# Appendix A SEPA Notification

## Determination of Significance and Request for Comments on Scope of EIS Henderson Basin 44 CSO Reduction Project

## Seward Park (Basin 44) CSO Reduction Project Comment on Draft EIS

**Examples below of basin-44 residents conveying roof rainwater runoff into the public street**

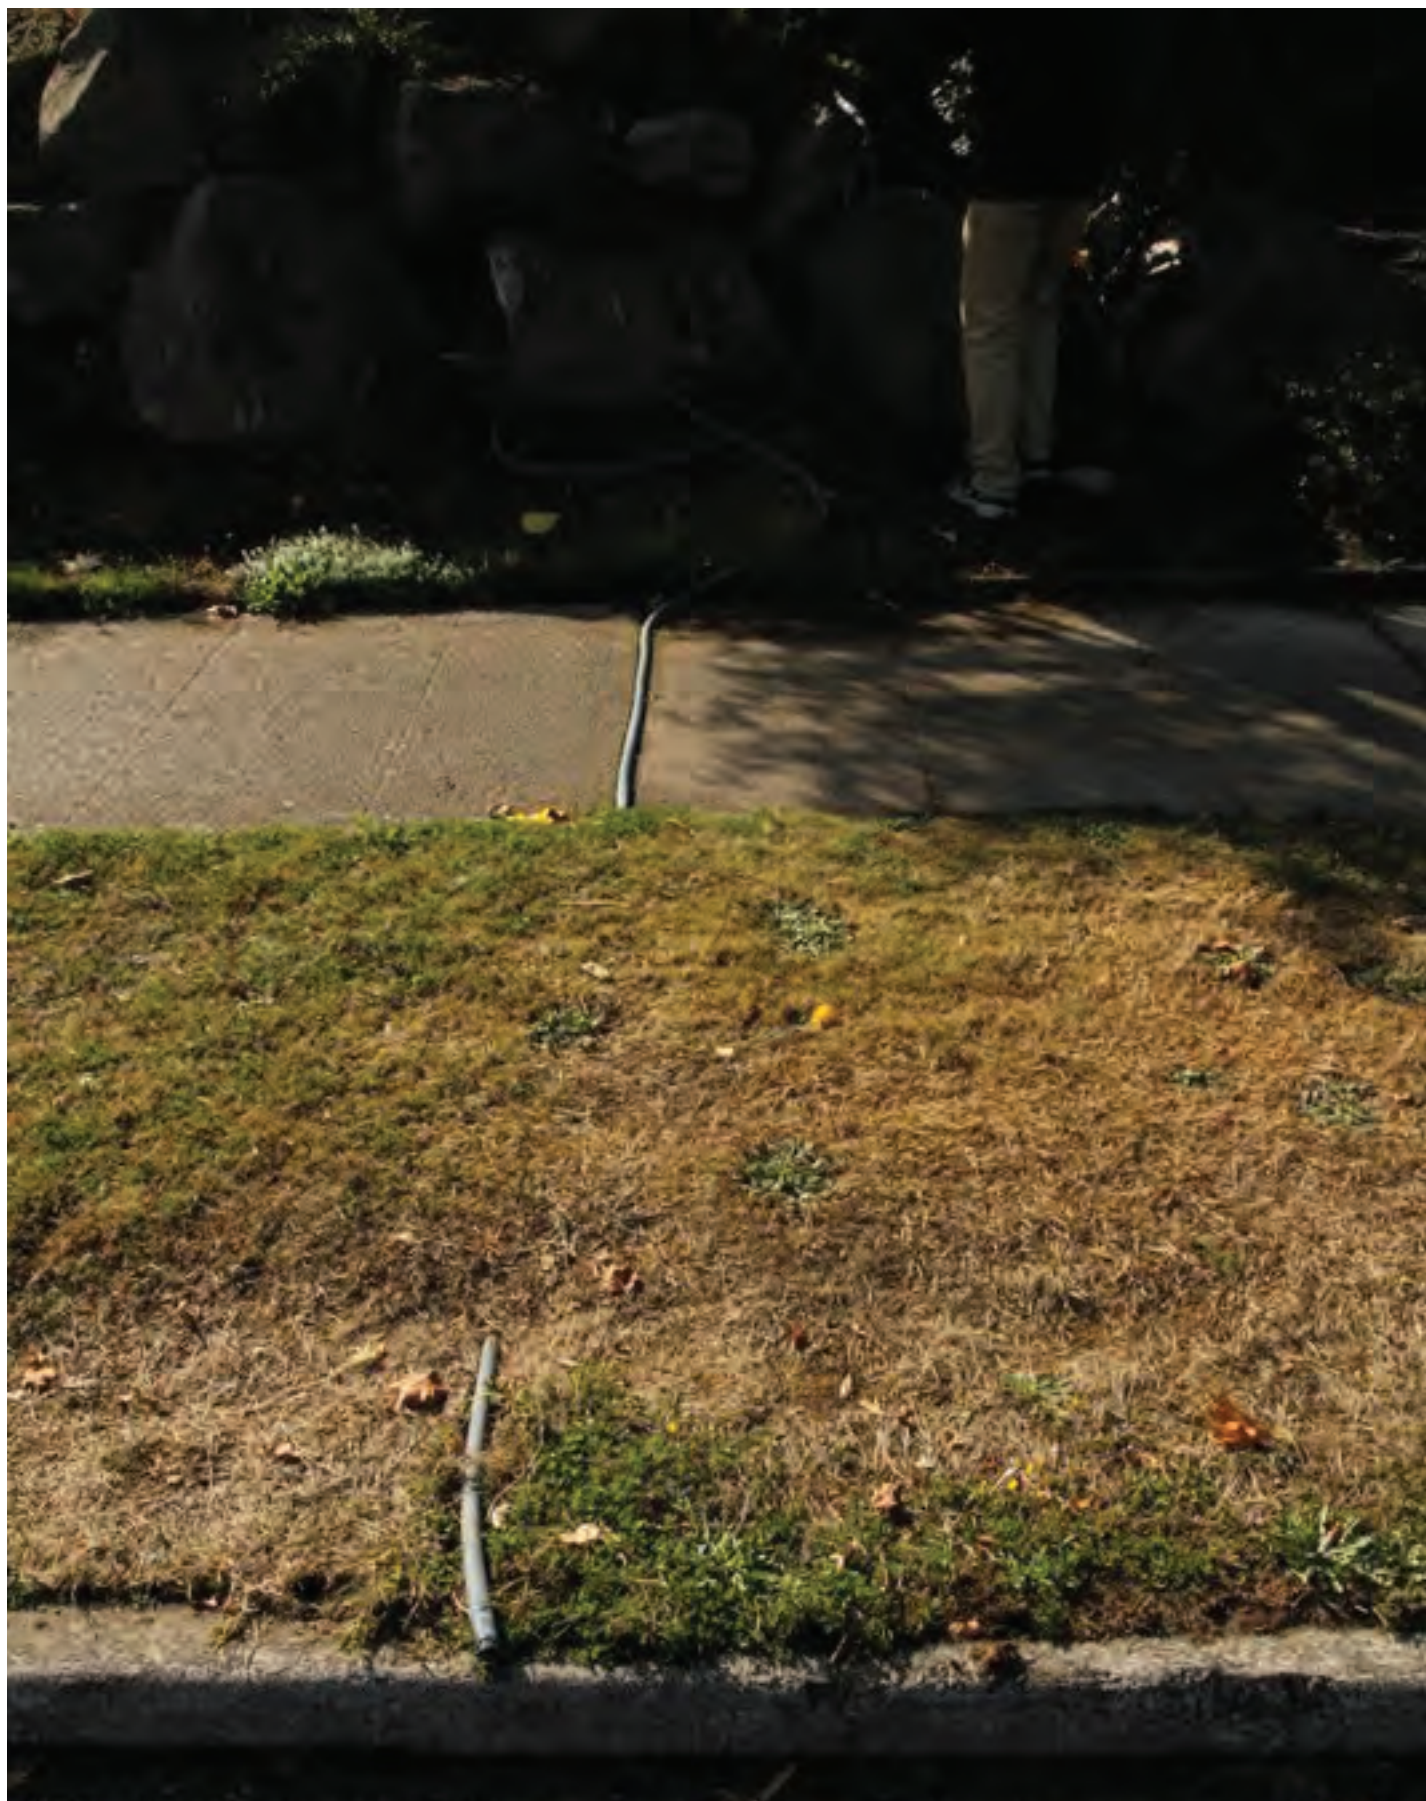
Both drainage systems on the same street

Rain gardens and cisterns in Basin 44 were evaluated in 2010-2011. However, because approximately 90-95 percent of the stormwater runoff in the streets is directed to a separate storm drain pipe instead of to a combined sewer pipe, rain gardens in the roadway would not help to reduce CSOs into Lake Washington. In addition, because of the steep slopes and low permeability of the soils in Basin 44, there appears to be limited opportunity for residential rain gardens on private property. Cisterns could provide some benefit, however, the efficiency and reliability of cisterns in reducing CSOs is much less than rain gardens or a centralized storage facility. This is because the location of the cisterns is not optimal (i.e., the most optimal location for storage is next to the CSO outfall, which is at the Southwest corner of Seward Park), and therefore the timing and availability of cistern storage is oftentimes not in alignment with when it is necessary to reduce CSOs. As a result, SPU anticipates that constructing rain gardens and cisterns in Basin 44 would address less than 10 percent of the required CSO volume.
